Application No. 10/648,237

## **REMARKS**

FIG. 1

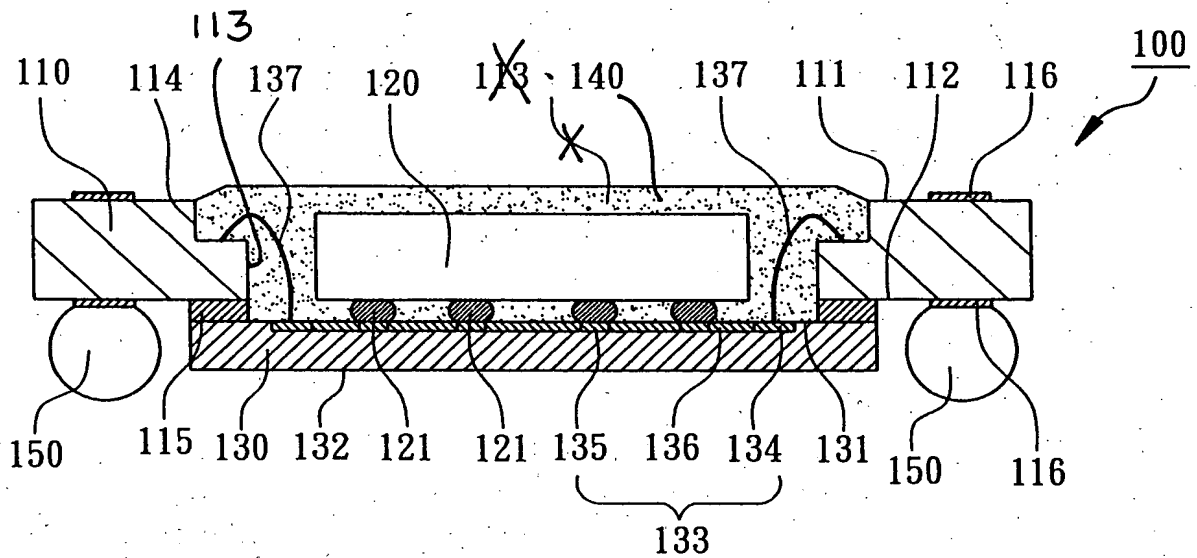
The Examiner has objected to the drawings under 37 C.F.R. § 1.84(p)(4) insofar as reference numbers "113" and "140" have been used to designate the same thing. Individual reference lines have been added so that reference number 113 indicates the opening and reference number 140 indicates the packaging body. No "new matter" has been added to the original disclosure by the proposed amendments to these figures. It is believed the foregoing amendments obviate the outstanding objections to the drawings.

Enclosed are new formal drawings of Figures 1 and 3, accompanied by a Letter to the Official Draftsperson. Figures 1 and 3 have been amended as illustrated in red on the attached photocopies. The new formal drawings include the noted changes.

Applicant has enclosed formal drawings of Figures 1 and 3 accompanied by a Letter to the Official Draftsperson. The new formal drawings include the proposed changes. Entry of the corrected drawings is respectfully requested.

FIG. 2

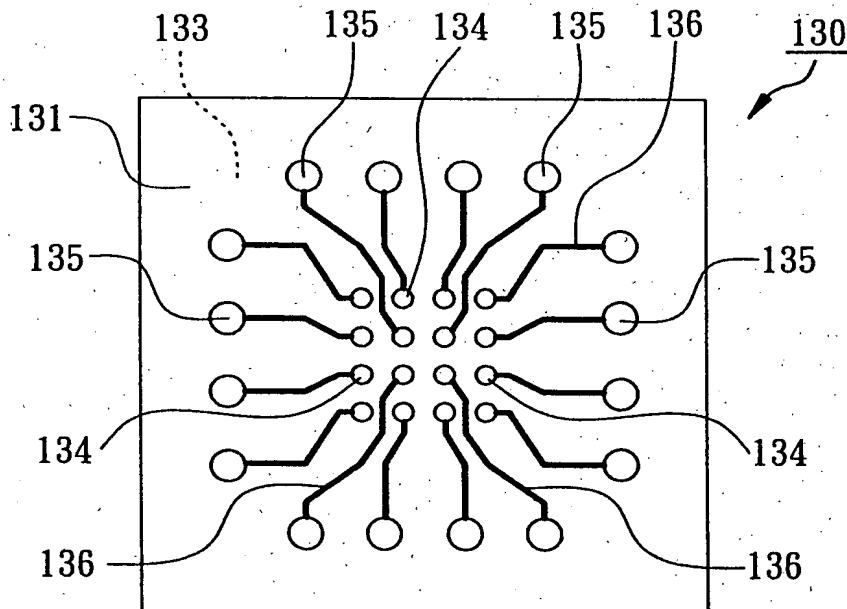
The Examiner has objected to the drawings under 37 C.F.R. § 1.84(p)(4) insofar as reference character "130" has been used to designate both the dummy die and package. Applicant respectfully notes that reference number "130" in Figure 2 is illustrating the dummy die and not the flip-chip package. Therefore, Applicant believes that no drawing corrections are necessary.
